**Supplementary Document on Japan's Proposal for Moderation of Safety Belt  
Retraction Force Standard in ECE R16**

Transmitted by the Expert from Japan

Fig 1

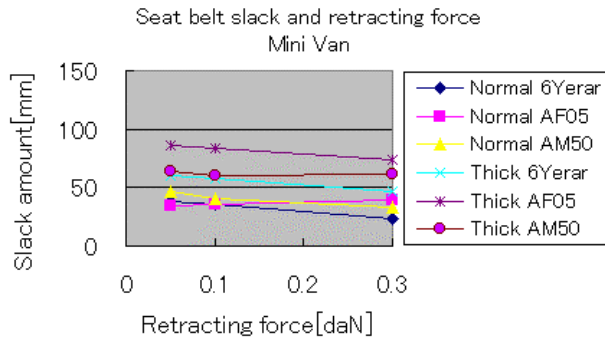
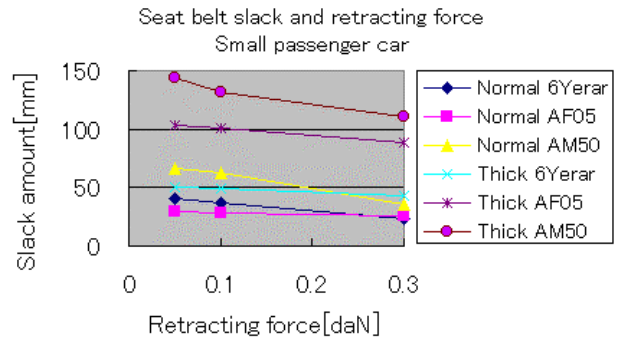
- 1) What will happen to the belt slack on the shoulder and laps if the belt retraction force is reduced?
- 2) What will happen to the belt slack on children and small women?

Figures 1 & 2: When retraction force was reduced, the amount of slack increased but this increase was moderate. This finding was obtained from all the groups of six-year children, small women, and adult males. The effect of retraction force on slack thus proved to be minimal among occupants of different stature.
